Re: JC Ranches Subdivision

I have reviewed the application to have RP05N45E101000 subdivided into twenty-five (25)) lots to be known as JC Ranches Subdivision and determined the parcel and proposed lots are suitable for sub-surface waste disposal systems to serve residences.

SUBDIVISION ON-SITE

MAP 1
 CONCEPT PLAN

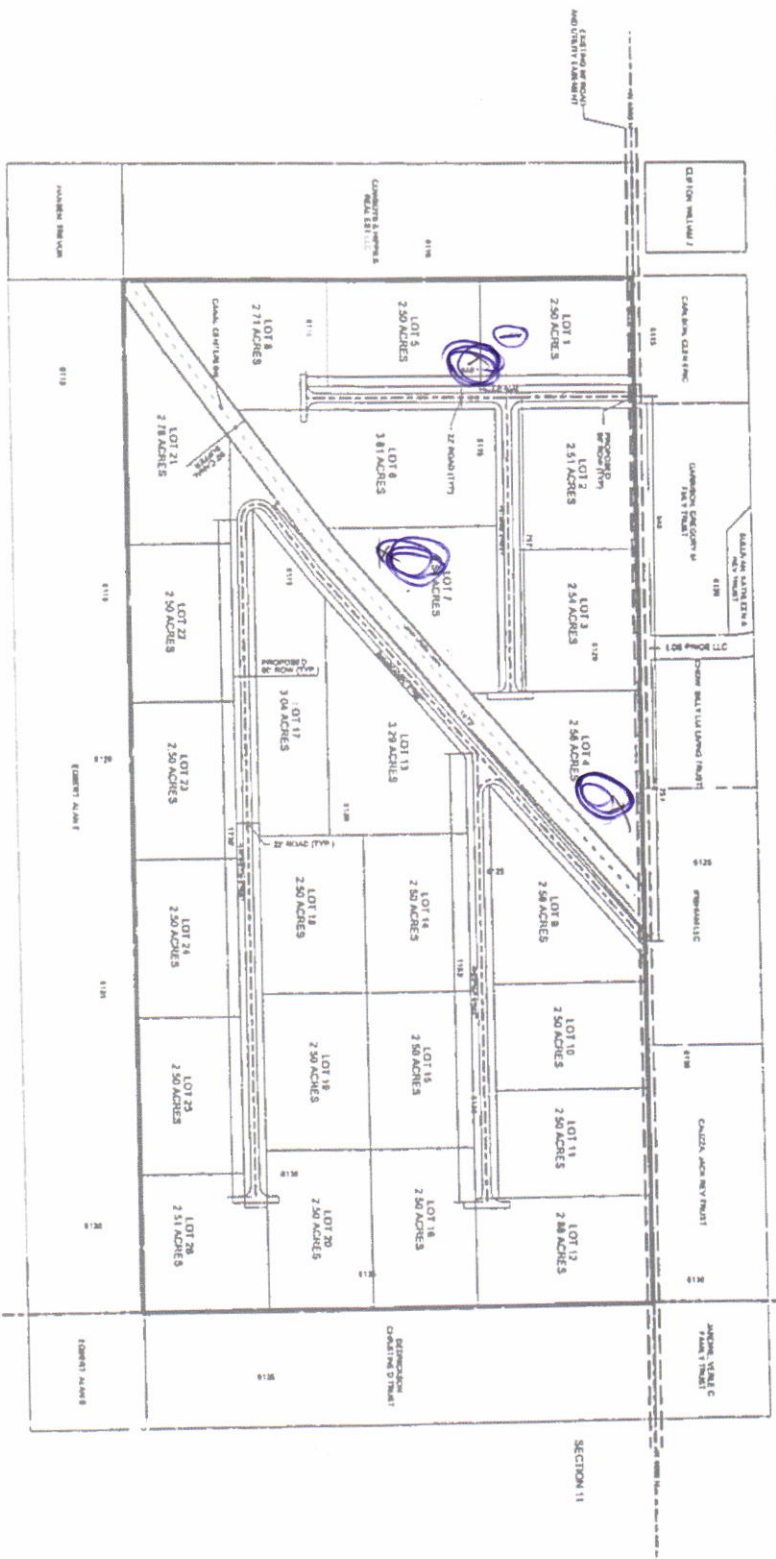
The parcel is cut diagonally by an irrigation canal/ditch. Due to deep fast water the eastern portion was not accessible. The soil horizon and rock content will not change from that observed in the western portion of the property. Adjacent properties to the south and east have been evaluated and have the same soil types and horizons. All areas of the parcel are suitable for sub-surface wastewater disposal systems. All drainfields should be sized using B1 application rate of 0.6 gpd/sq ft due to the rock content in the lower layer.

Irrigation ditch/canal

Eastern Idaho Public Health gives preliminary approval of the application to divide RP05N45E101000 creating the JC Ranches Subdivision. The site is suitable for residential sub-surface waste disposal. Individual subsurface sewage disposal systems may be allowed in accordance with IDAPA 58.01.03 and the Technical Guidance Manual for Individual Subsurface Waste Disposal. All current Idaho Rules must be met. Suitability criteria and required separation distances are to be maintained.

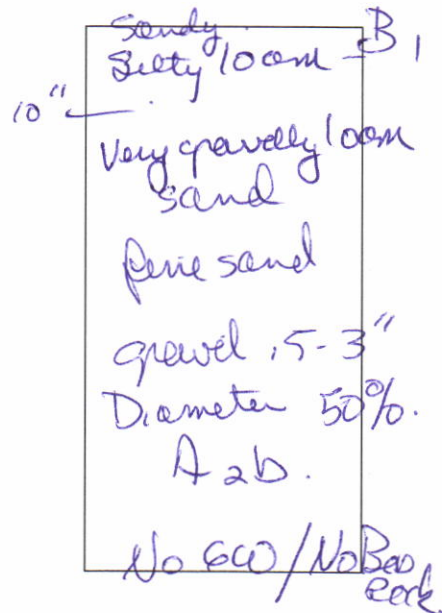
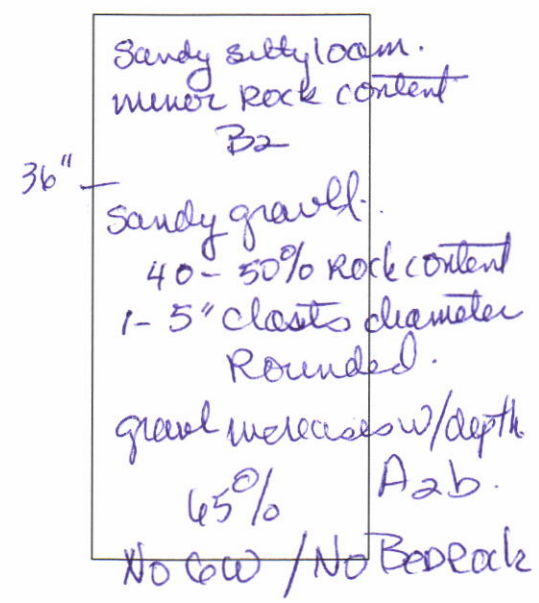
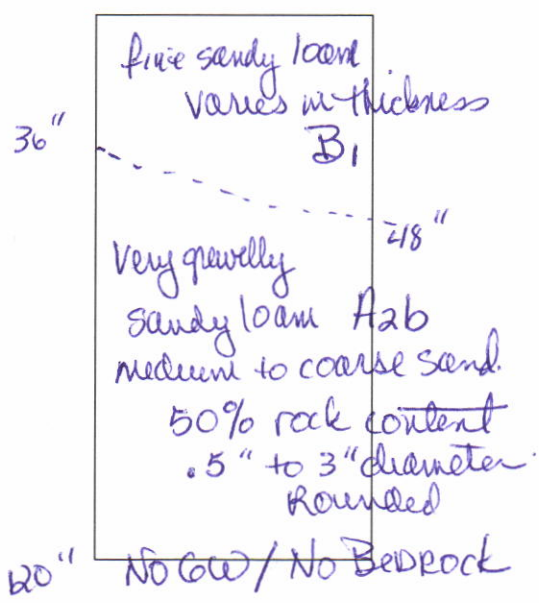
COMMENTS:
No problems w/ suitability for septic systems. 50' separation from irrigation ditch required from any portion of septic system.
